INDESIT company

Model type:
TAAN2

Commercial code:
F033934

51420c0 Exploded views

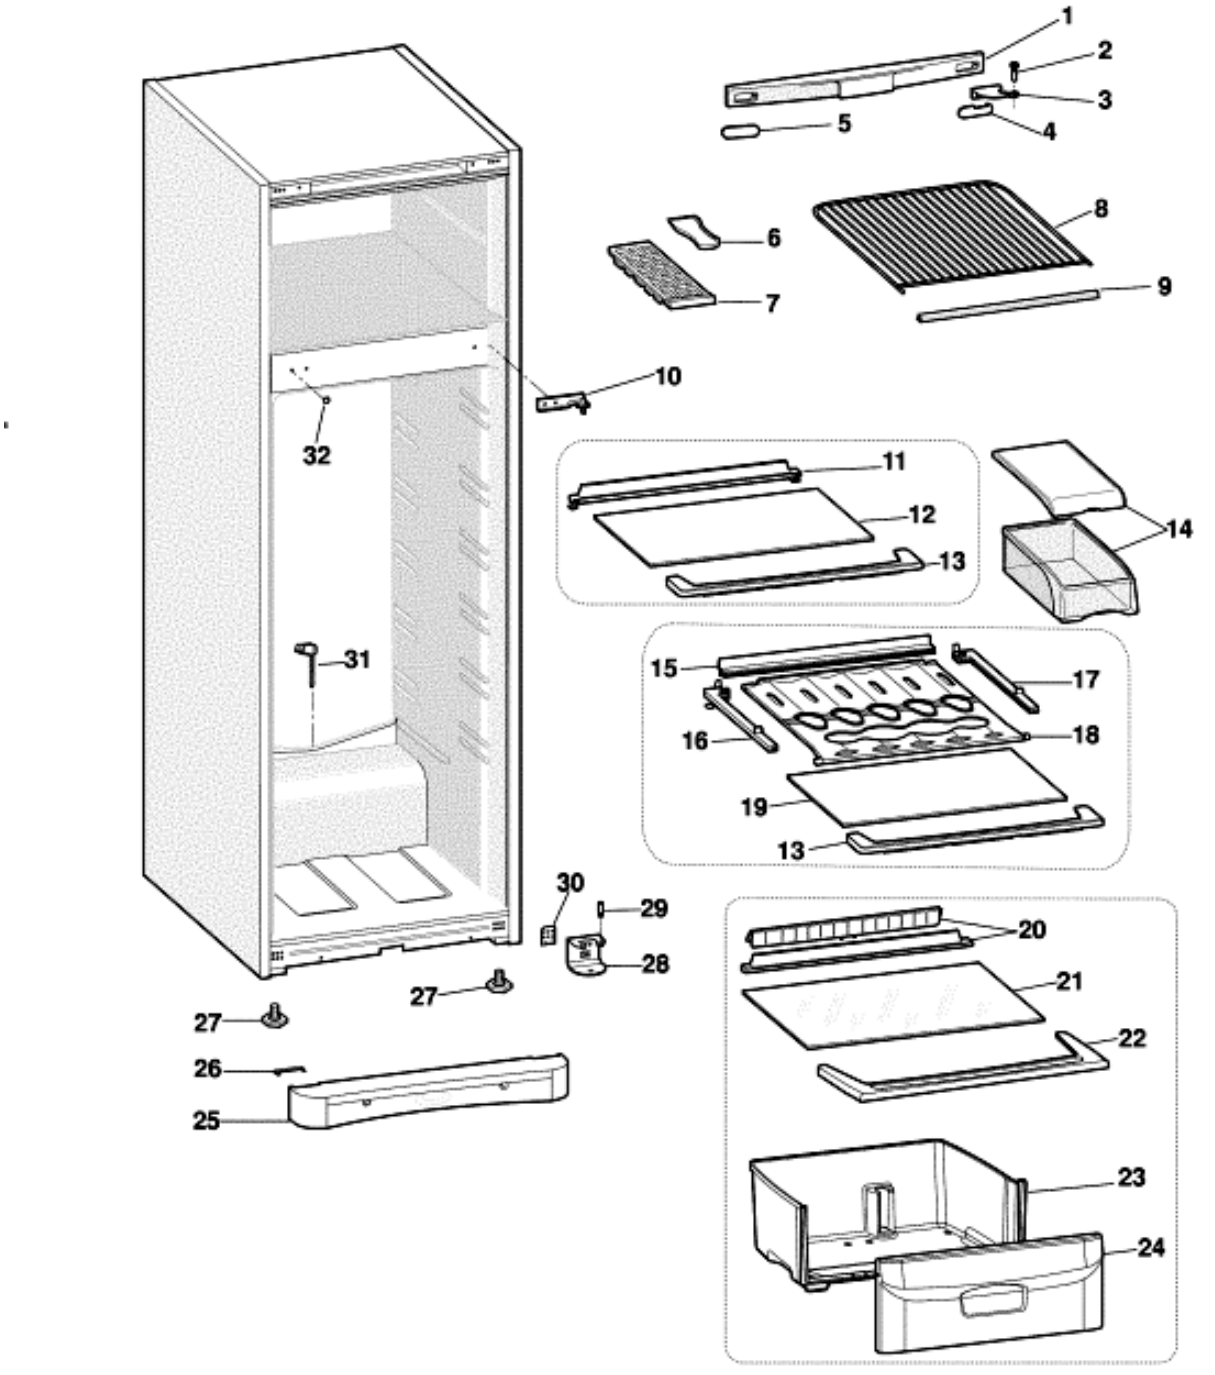
n2510j00: SUBSTITUTION LOWER HINGE PIN

In order to make better the assembly and to prevent an accidental unscrewing of lower hinge pin with consequent falling down of the door, original pin has been substituted by another one longer.

C00017658 (13.5mm) --> C00259768 (21mm) --> C00281425 (23mm)

For quality issues on interested models is managed only the last one C00281425 (23mm).

51421m0 Exploded views

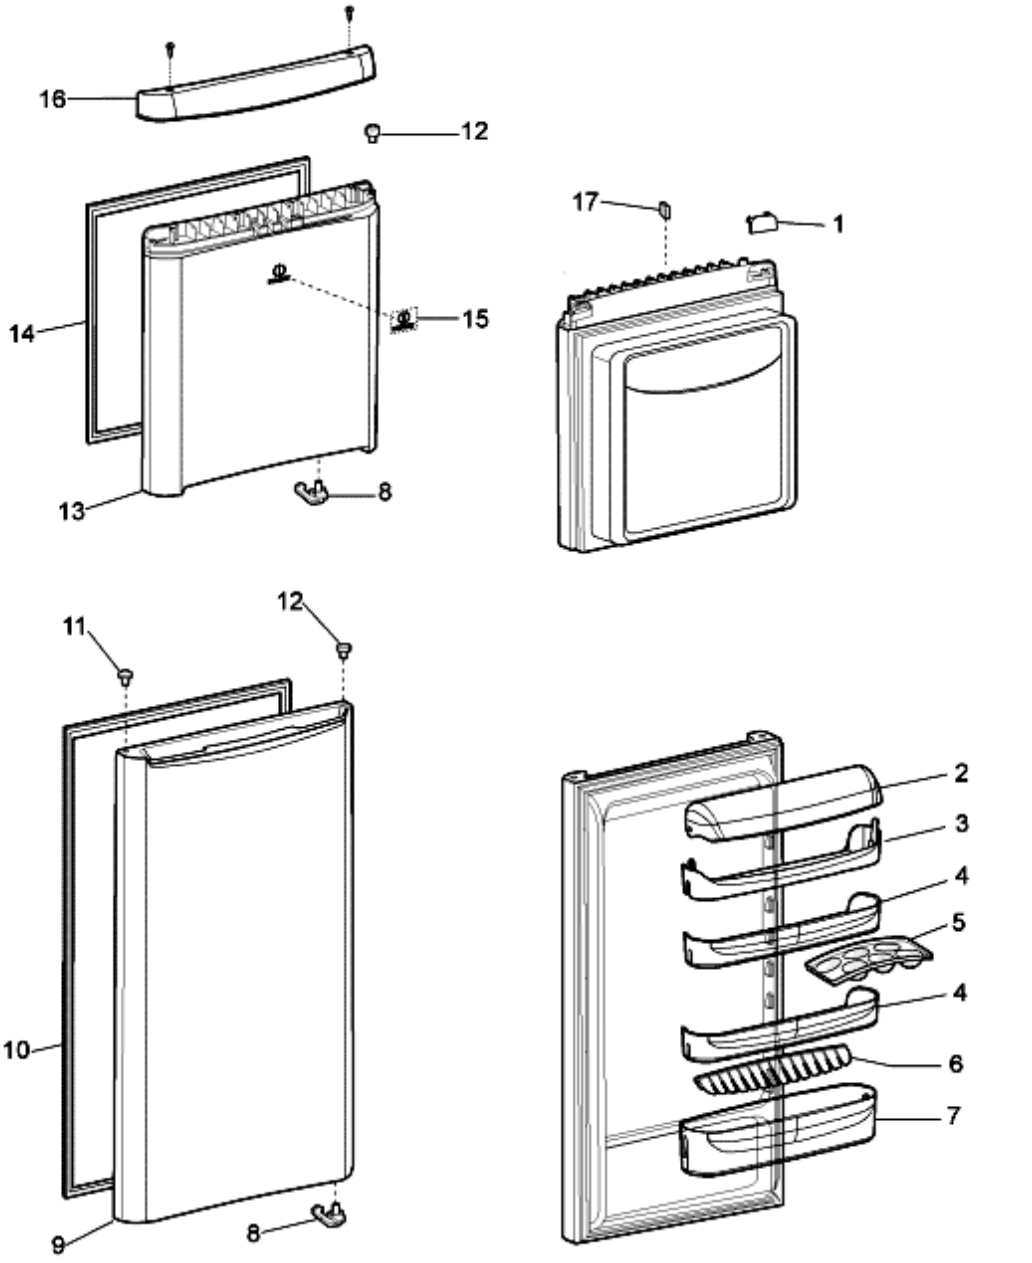
n2511b02: ELIMINATION COVER FOR UPPER DOOR SHELF-INTERNAL ACCESSORIES RESTYLING

Cover for upper door shelf has been eliminated. The upper door shelf has been standardized with the middle one. Subsequently has been standardized with transparent internal accessories instead of those in light blue colour once stock has depleted.
